UNITED STATES PATENT AND TRADEMARK OFFICE

APPLICATION NO.	FILING DATE	FIRST NAMED INVENTOR	ATTORNEY DOCKET NO.	CONFIRMATION NO
10/083,093	02/26/2002	Jeffrey J. Shea	10557/266546	5422
30559	7590 06/14/2006		EXAMINER	
CHIEF PATENT COUNSEL			RAMANA, ANURADHA	
SMITH & NI 1450 BROOK	EPHEW, INC. KS ROAD		ART UNIT	PAPER NUMBER
MEMPHIS, TN 38116			3733	
			DATE MAILED: 06/14/2000	6

DETAILED ACTION

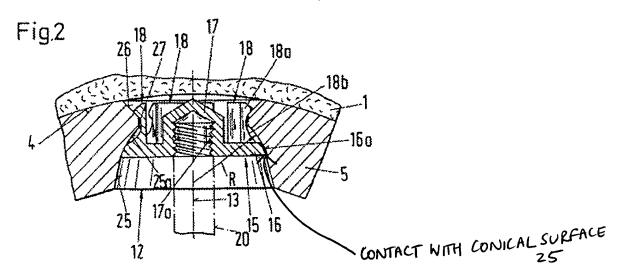
Oehy et al. disclose that openings 12 have a conically shaped inner end portion 25 and an approximately spherical support surface 25a formed between the end portion and the circumferential part 27 (col. 3, lines 3-8). Oehy et al. also disclose that the sealing part 16 of closure plug or "insertion member" 15 can be made cylindrical or conical for cooperation with support surface 25a (col. 4, lines 7-12). It is noted that sealing part 16a is locked relative to conical surface 25, i.e., fixed in position relative to surface 25, and contacts conical surface 25 as shown in marked up Figure 2 below.

It is further noted that although the above discussion is made with reference to plug 16, the same reasoning applies to fastener 14 placed in opening 12.
